**STAFF REPORT**

**CASE NUMBER:** P.D. 08-319

**DEVELOPMENT NAME:** Grace St. Luke's School Planned Development

**REQUEST:** A planned development to permit institutional uses consisting of a private, church sponsored, day school (grades pre K-9)

### PROPOSED OUTLINE PLAN

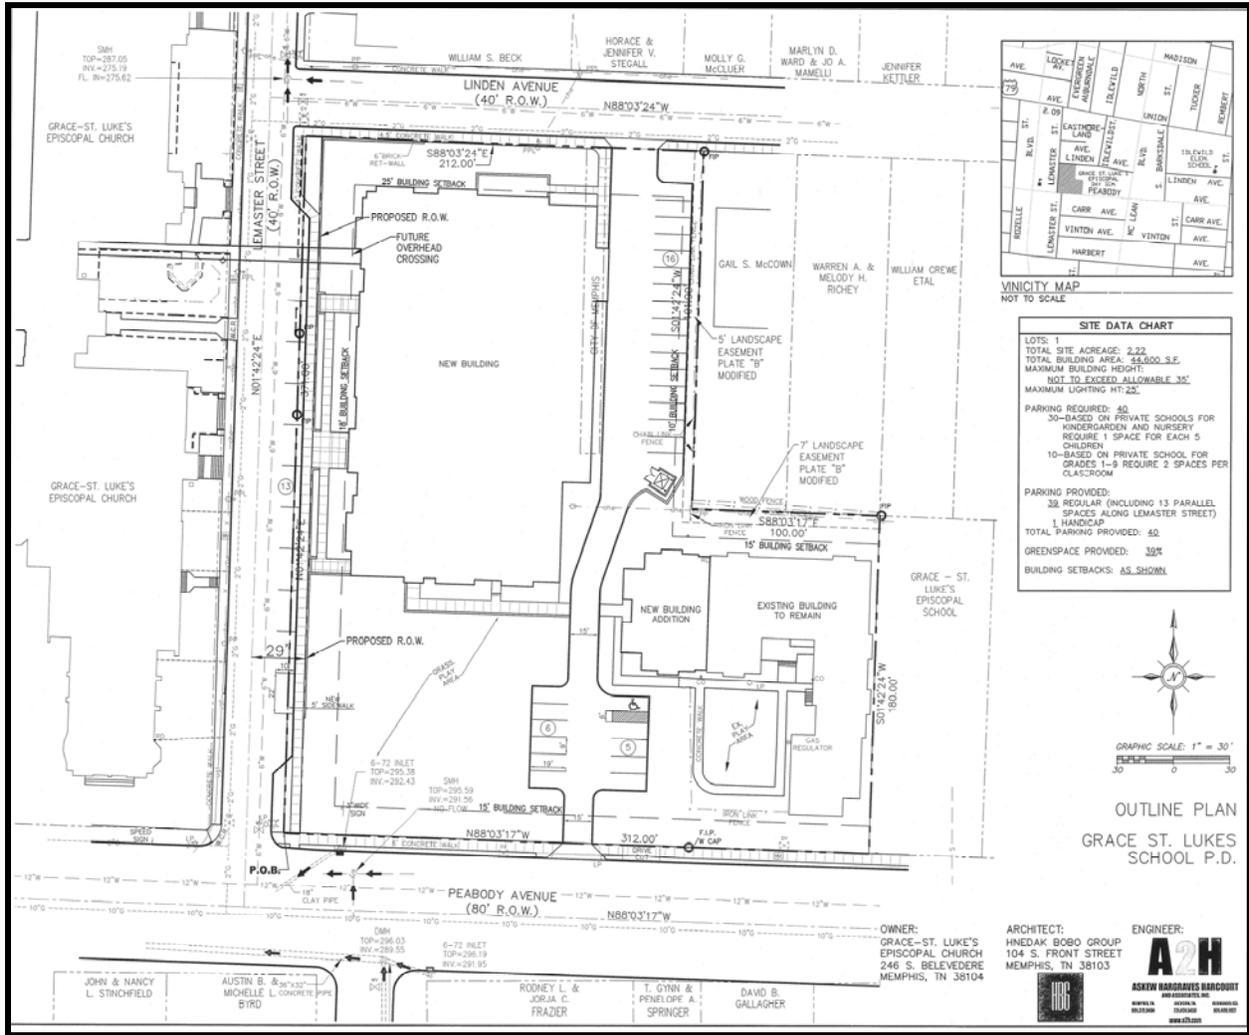
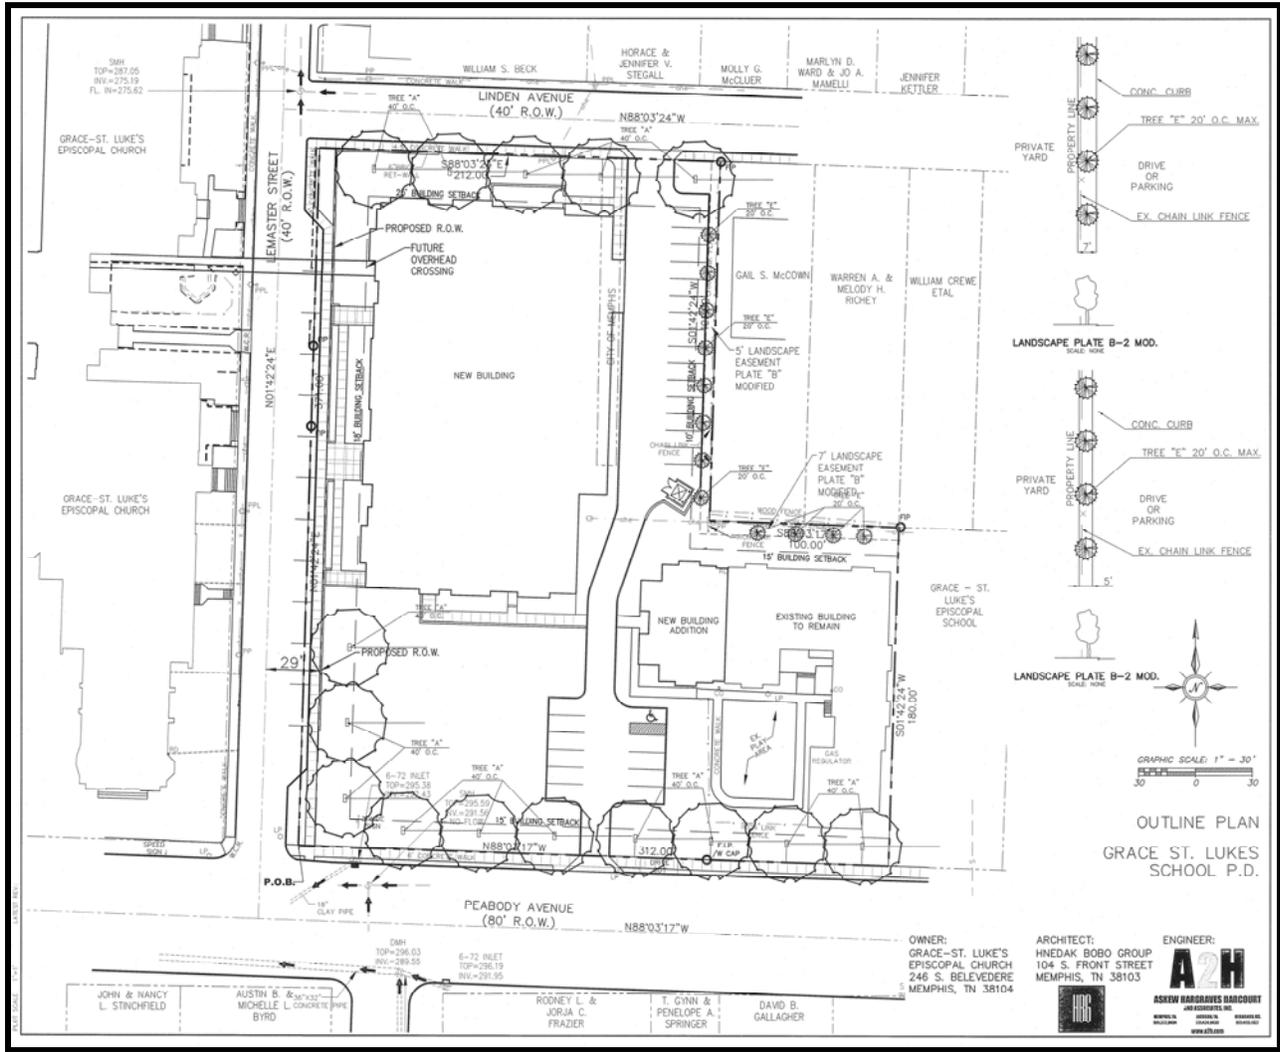
5. The second issue pertains to comments and recommendations from the City Engineering Office which could cause a redesign of the proposed site plan making the review and a recommendation on this application by staff premature at this time.

The second issue is the number of changes that are being recommended by City Engineering Office. These changes range from the amount of right-of-way dedication needed for LeMaster Street to the compliance with the American with Disability Act (ADA) requirements for this site. Also, there is an issue with the applicant's request to include a number of on-street parking spaces within the total required parking count for this project. In addressing the engineering comments, a redesign of the site plan could be required which would make a recommendation by staff on the current site plan premature at this time. Additional time is needed to allow the applicant to work with City Engineering to resolve these issues.

- 3 On-street parking shall not be included in the required parking count.
- 4 Dedicate and improve the full length of Lemaster between Peabody and Linden 29.5 feet from centerline in accordance with Subdivision Regulations.

- 5 Sidewalks constructed immediately adjacent to the curb shall be a minimum of 6 feet wide, rather than the 4 feet shown on the concept plan..
6. Dedicate a 15 foot property line radius at the intersections of LeMaster/Peabody and LeMaster/Linden, and improve with ADA compliant access ramps, all in accordance with the design standards of the City of Memphis, Division of Engineering.

7. The proposed curb cuts on Linden and on Peabody shall be constructed at a depth of 10' from face of curb to back of the curb cut with a five foot length of 10' wide sidewalk at each end of the curb cut. A transition length of 5' shall connect the existing sidewalk width to the 10 foot width.

9. Install signs and pavement markings for one-way curb cut on Peabody Ave.
10. Install fence around play area on Peabody and on Lemaster.
11. Minimum vertical clearance shall be maintained for the future overhead crossing.
12. An application for closure is required for the City of Memphis ROW shown on the site plan running south of Linden.
13. Where will the children be crossing on Lemaster until the overhead crossing is constructed?
14. The City Engineer shall approve the design, number and location of curb cuts.
15. Any existing nonconforming curb cuts shall be modified to meet current City Standards or closed with curb, gutter and sidewalk.

A. Dedicate and improve the full length of Lemaster between Peabody and Linden 29.5 feet from centerline in accordance with Subdivision Regulations.

B. Sidewalks constructed immediately adjacent to the curb shall be a minimum of 6 feet wide, rather than the 4 feet shown on the concept plan.

C. Dedicate a 15 foot property line radius at the intersections of LeMaster/Peabody and LeMaster/Linden, and improve with ADA compliant access ramps, all in accordance with the design standards of the City of Memphis, Division of Engineering.

D. The proposed curb cuts on Linden and on Peabody shall be constructed at a depth of 10' from face of curb to back of the curb cut with a five foot length of 10' wide sidewalk at each end of the curb cut. A transition length of 5' shall connect the existing sidewalk width to the 10 foot width.
